Access Compliance Report

Public Rights-of-Way

(Curb Ramps)

Intersection ID: 5904	Main Street: COULWOOD_DR	Cross Street: MELLWOOD_DR	Location:	E
ADA ID: CE73297B3D75	Ramp Type: Directional1	Initial Pass/Fail: Pass	Overall Compliance: No	Severity Score: 2.5

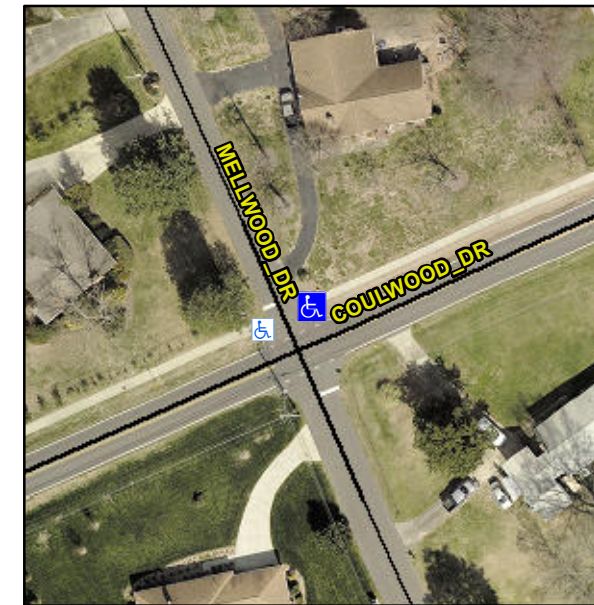
R304.2.1, R304.2.2-Perp, R304.3.2-Para, R304.5.3, R305.1.4, R305.2

Compliance	Description	Data	Compliance	Description	Data
N/A	Ramp Length (in)	72.0	Yes	Grade Break?	Yes
Yes	Ramp Width (in)	60.0	Yes	Grade Break Slope (%)	1.6
Yes	Ramp Slope (%)	1.9	No	Grade Break XSlope (%)	2.3
Yes	Ramp XSlope (%)	1.8			
N/A	Flare Type LT	N/A	N/A	Flare Type RT	N/A
N/A	Flare Slope LT (%)	N/A	N/A	Flare Slope RT (%)	N/A
N/A	Flare Traversable LT?	N/A	N/A	Flare Traversable RT?	N/A
No	Landing Length (in)	46.0	Yes	DWS Provided?	Yes
Yes	Landing Width (in)	60.0	Yes	DWS Contrast?	Yes
No	Landing Slope (%)	2.5	Yes	DWS Length (in)	24.0
No	Landing X Slope (%)	2.5	No	DWS Full Width?	No
N/A	Landing Curb? (Y/N)	No	Yes	DWS Offset LT (in)	16.5
N/A	Shared Landing?	No	No	DWS Offset RT (in)	13.0
Yes	Gutter Ponding?	No	Yes	Gutter Slope (%)	2.2
Yes	Gutter Lip Ht (in)	0.0	Yes	Gutter X Slope (%)	1.5
N/A	Painted X Walk1?	No		Road Slope (%)	1.1
	X Walk 1 Direction	To SW		Road X Slope (%)	1.1
	X Walk 1 Width (in)	N/A		Clear Space?	Yes

X Walk 1 Slope (%)	1.1	N/A	Clear Space to XWalk (in)	N/A
	X Walk 1 X Slope (%)	1.1	Yes	Storm Grate/Utility Hazard?	No
N/A	Ramp inside XWalk1?	N/A		Storm Grate/Utility Type	
Yes	Any Obstructions?	No			N/A
	Obstruction Type		Yes	Surface Condition? (G/P)	Good
			N/A	Curb Slope (%)	0.1

Remove & Replace Entire Ramp.
